From: Candice Andrews [candice@webberarchitects.com]
Sent: Thursday, 14 September 2017 8:43 AM
To: Tim Hayes; Sandra Hinchey; Luke Keating; Fernanda Espinoza
Subject: Fwd: lot number: 412 plan number: DP1063902

Please see the below response from DPI. Looks like 10m set back for the creek.

Figure 2. The Strahler System

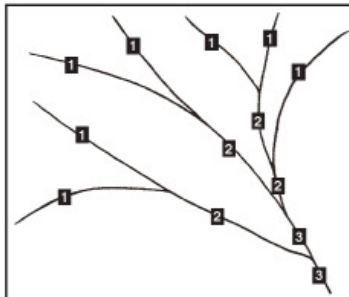
The Officer of Water recommends a VRZ width based on watercourse order as classified under the Strahler System of ordering watercourses and using current 1:25 000 topographic maps (see Figure 2 and Table 1). The width of the VRZ should be measured from the top of the highest bank on both sides of the watercourse.

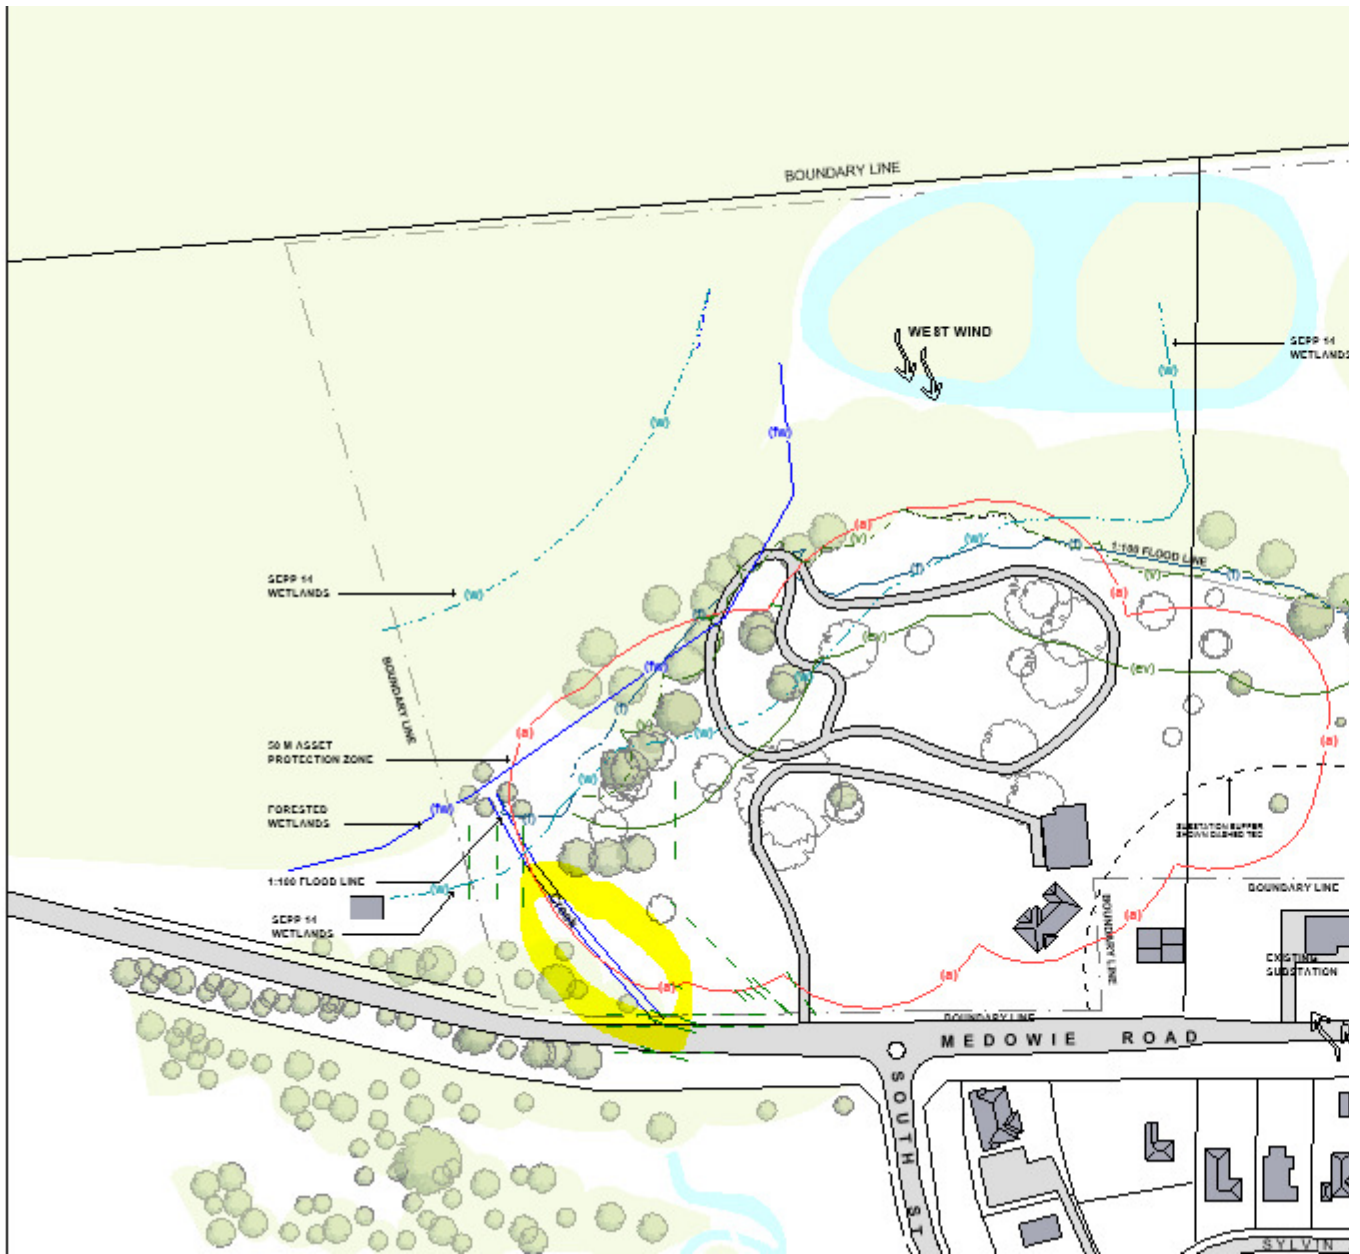
As discussed earlier please see the below image taken from google maps. My inkling is that it is an easement.

Thank you for your email and time on the phone today. Based on the information provided and review of imagery it would appear that this may meet the definition of a river under the WMA 2000. It is also noted that there is a SEPP 14 wetland mapped on the property would also be considered waterfront land and require consideration as part of the SEE.
